TIPPERARY COUNTY COUNCIL

TEMPLEMORE INFILL WORKS

STAGE 1 ROAD SAFETY AUDIT

Document Control Sheet	
Document Reference	11007 TR01 RSA
Report Status	ISSUE
Report Date	January 2022
Current Revision	D01
Client:	Tipperary County Council
Client Address:	Tipperary County Council Civic Offices Emmet Street, Clonmel Co. Tipperary
Project Number	11007

Figure 2-4 Extract of Proposed Footway widths from preliminary design drawings

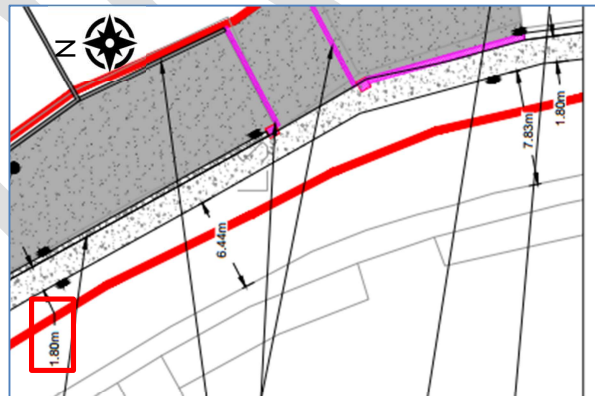
Proposed Footway Widths

The audit team note that the proposed width is in line with the absolute minimum standard footway widths, potentially creating a passing hazard for pedestrians forcing them onto the existing carriageway creating a conflict point between vehicles and pedestrians, in particular for wheelchair users and those pushing buggies / prams.

The Design Team should ensure the footway width is adequate for passing pedestrian movements demands.

Figure 2-6 Proposed Streetscape Design at the Junction of the N62 and Blackcastle Road

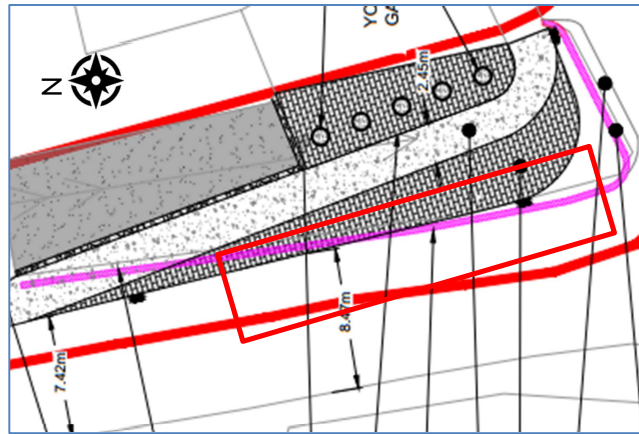
On street Parking - Streetscape Parking

A streetscape area is proposed at the junction of the N62 with the Blackcastle Road within the infilled lands. The Audit Team are concerned the wide streetscape area may give rise to vehicles parking on it. This may result in potential conflicts with pedestrian and vehicles and also give rise to junction visibility issues leading to potential collisions at the junction.

The Design Team should provide appropriate measures to prevent vehicles parking on the paved area within the proposed design.

Figure 2-7 Existing Pedestrian Desire Lines across Blackcastle Road

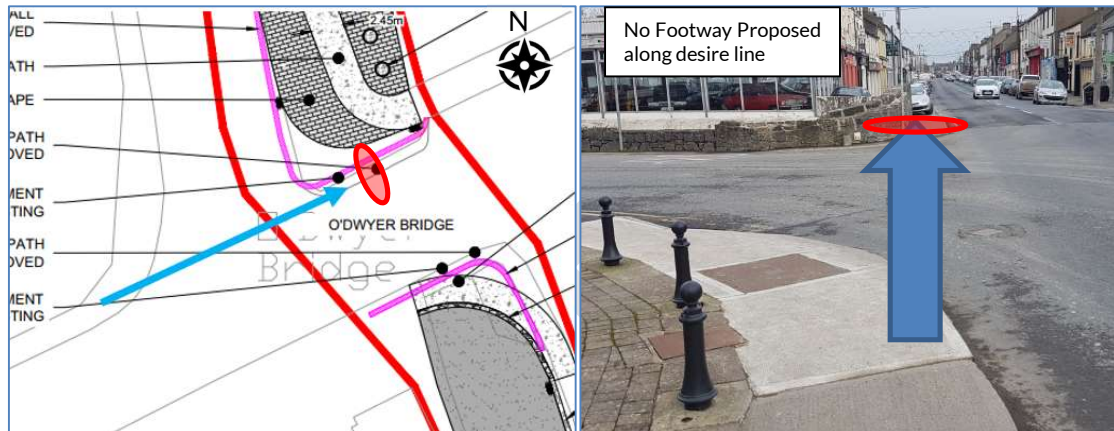
Pedestrian Desire Lines

At the streetscape area at the junction of Blackcastle Road and the N62, the roadway at O'Dwyer's Bridge is proposed to be widened and the footway set back behind the existing parapet line. The Audit Team are concerned this will affect the pedestrian desire lines crossing Blackcastle Road. In particular, the existing infrastructure (i.e. drop kerbs) on the left hand side of the junction will guide visually impaired VRUs into the road carriageway, potentially leading pedestrians stranded in the carriageway and collisions between motorised and pedestrians.

The Design Team should review the pedestrian desire line based on the proposed design and ensure the design ties into the existing road infrastructure. Provisions for visually impaired road users should be provided in the design (i.e. tactile paving at road crossing).

Figure 2-8 Proposed N62 / Blackcastle Road Junction Width

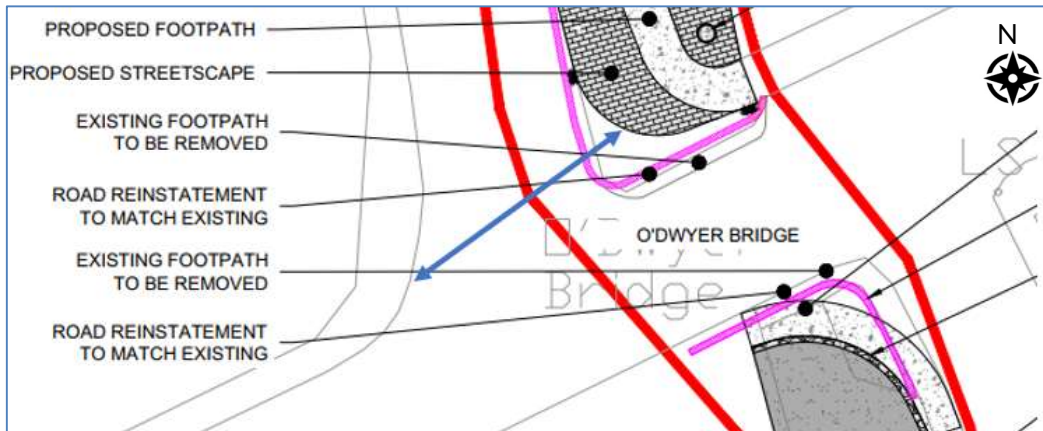
Width of Proposed Junction – N62 / Blackcastle Road

The proposed design shows work only to the eastern side of the N62 / Blackcastle Road junction. The existing wide corner radius on the west side of the junction, in conjunction with the increased eastern corner radius will potentially give rise to higher vehicle speeds turning at the junction. It will also result in increased pedestrian crossing times, which will increasing the risk of collisions between motorised and non-motorised road users.

The Design Team should provide junction widths in accordance with guidance from the Design Manual for Urban Roads and Streets in accordance with the urban road speed.

Figure 2-9 Eastbound Approach to the N62 / Blackcastle Road / The Mall Junction

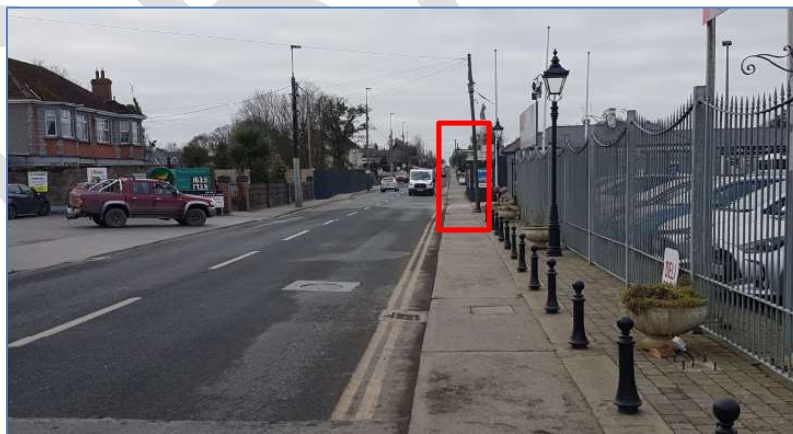
Junction Warning Signage

The Audit team observed onsite the presence of warning signage on the minor road approaches to the N62 staggered junction. Warning signage is being provided on the major road approaches in both directions at quite a distance away from the junction. Significant distance of warning signage to hazards may result in lack of awareness of drivers, believing the warning signs are no longer valid to the area. This could give rise to head on collisions, turning collisions or rear end collisions at the junction as drivers may.

The Design Team should provide staggered junction warning signage on the major road at suitable distances from the hazard.

Figure 2-12 Interface of proposed footway and existing footway alignment

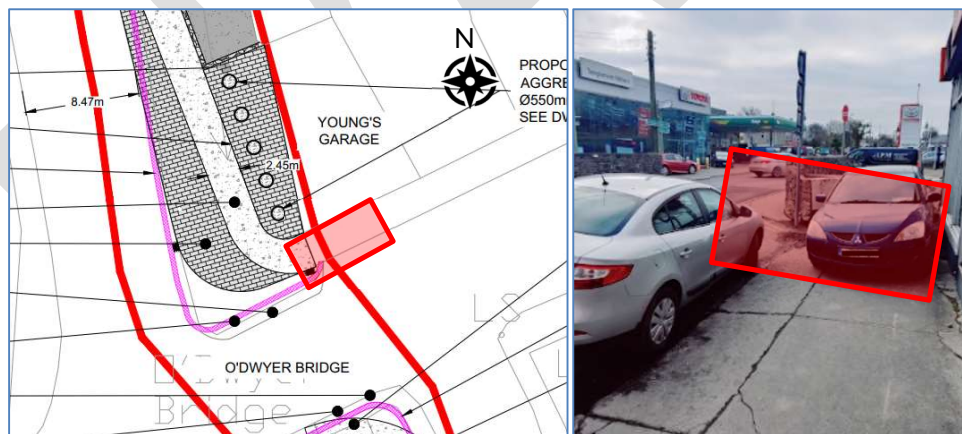
Parked Cars and Pedestrian Facilities

The Audit Team observed parking to the east of the N62 / Blackcastle Road junction fronting Young’s Garage. The proposed footway alignment tying into the existing footway, may overlap with this area, displacing vehicles resulting in vehicles parked in closer proximity to the junction negatively impacting on visibility. Or vehicles parked on the proposed footway impeding pedestrians.

The Design Team should ensure adequate visibility is provided at the junction clear of parked vehicles.

Figure 3-1 Restricted Footway Width on Blackcastle Road adjacent to scheme

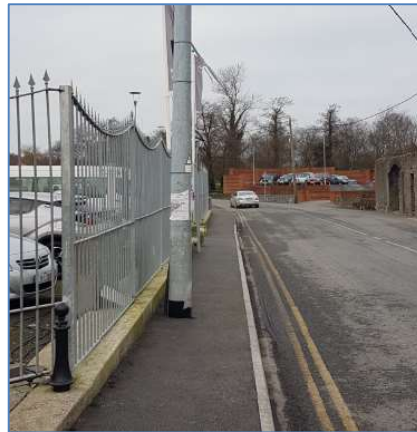
Restricted Footpath Widths Adjacent to Proposed Works

The Road Safety Audit Team noted during the site visit that adjacent to the scheme are areas of restricted footpath widths due to temporary and permanent fixtures.

Appendix C – Problem Map

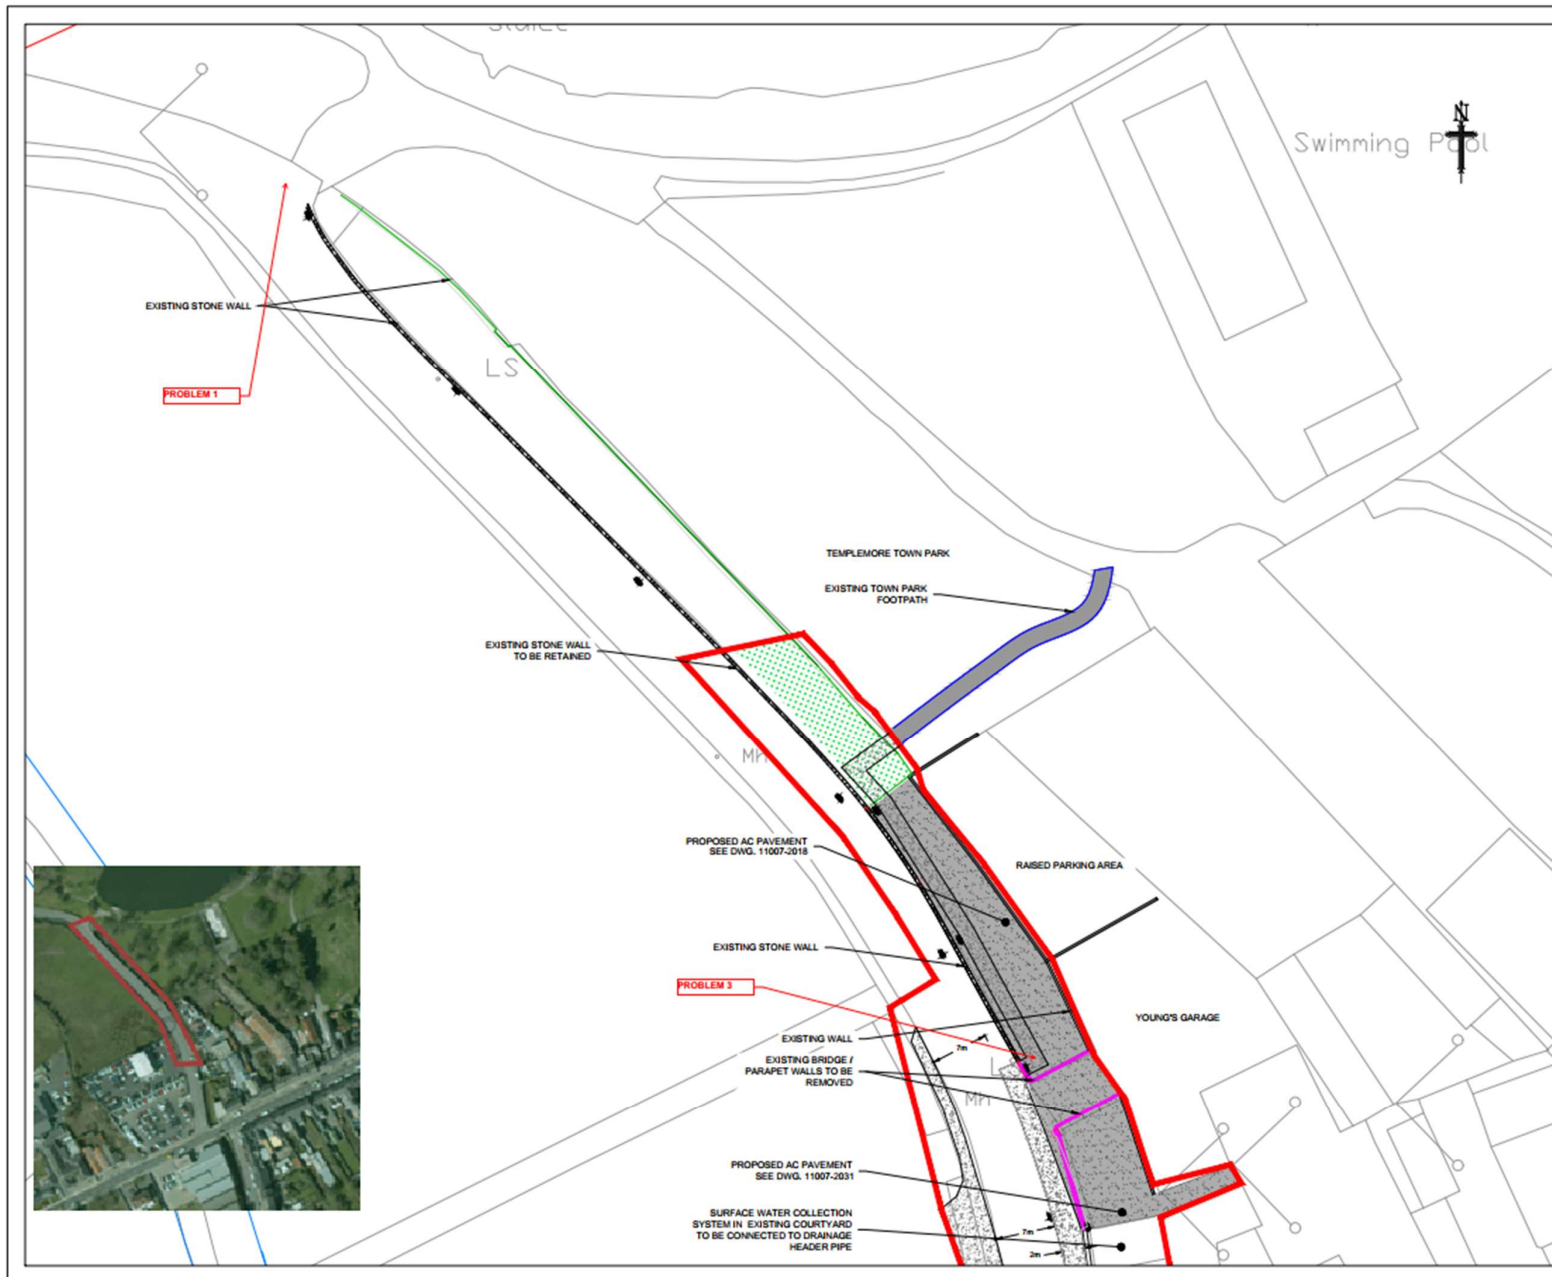
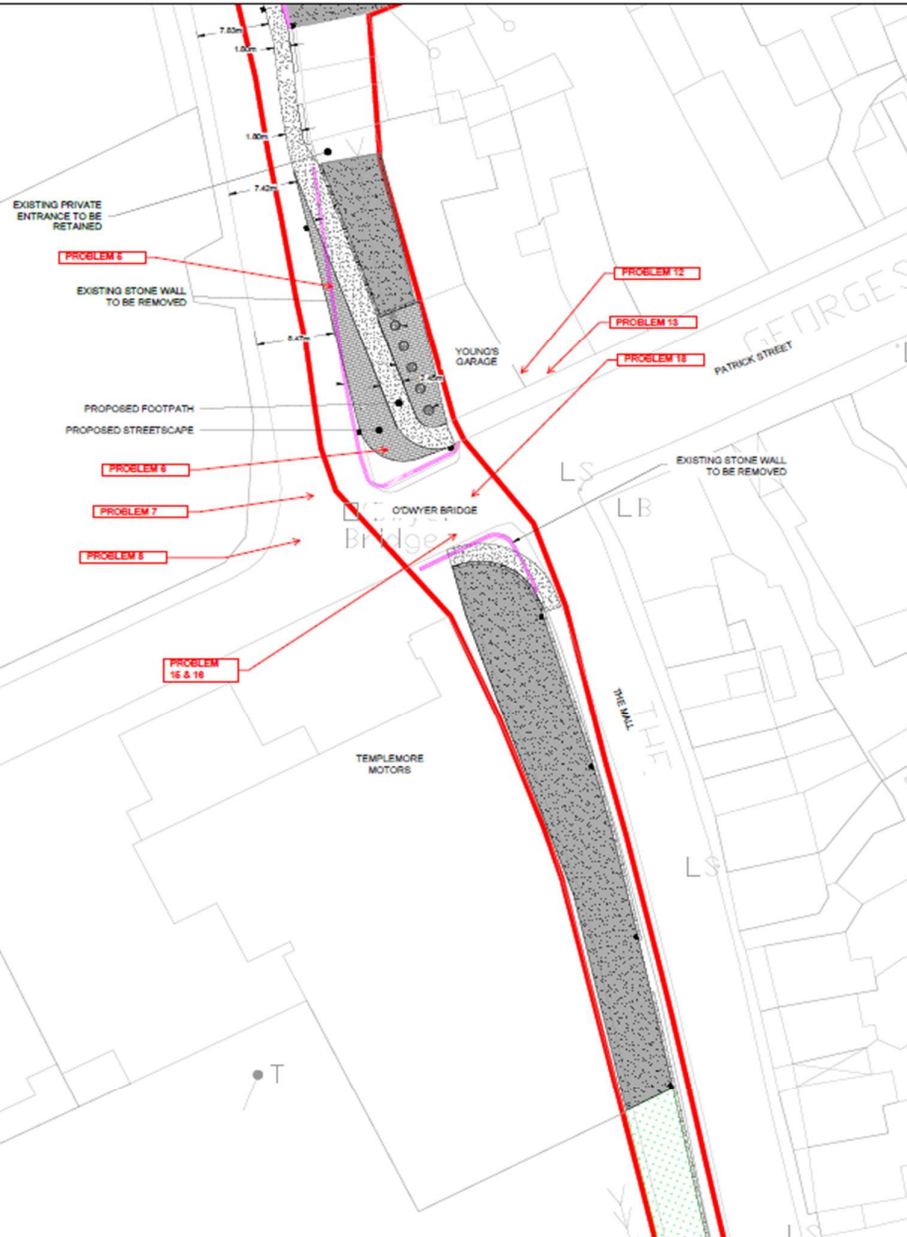
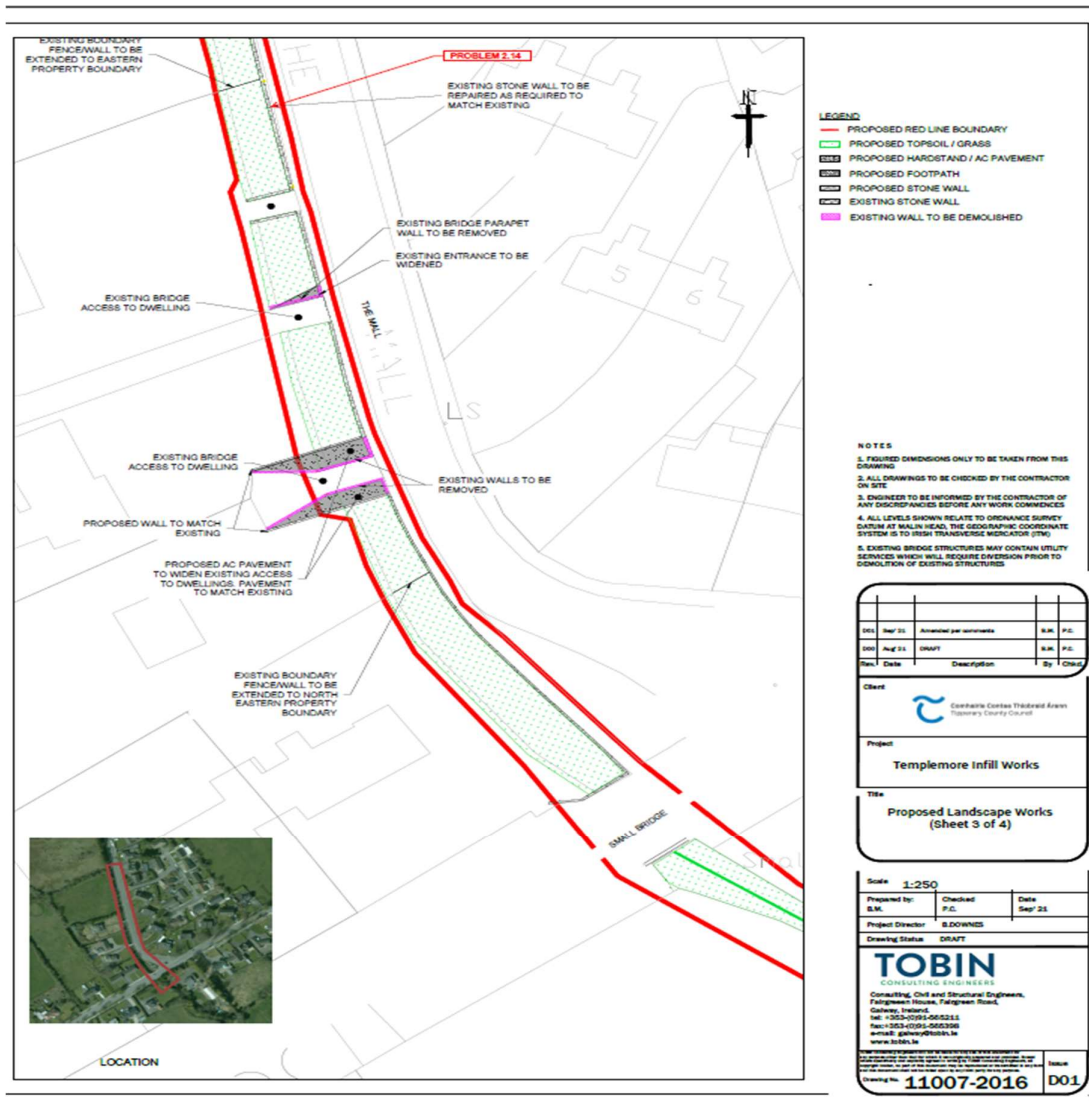
GENERAL PROBLEMS APPLICABLE THROUGHOUT THE SCHEME:

- PROBLEM 4
- PROBLEM 9
- PROBLEM 10
- PROBLEM 11
- PROBLEM 17
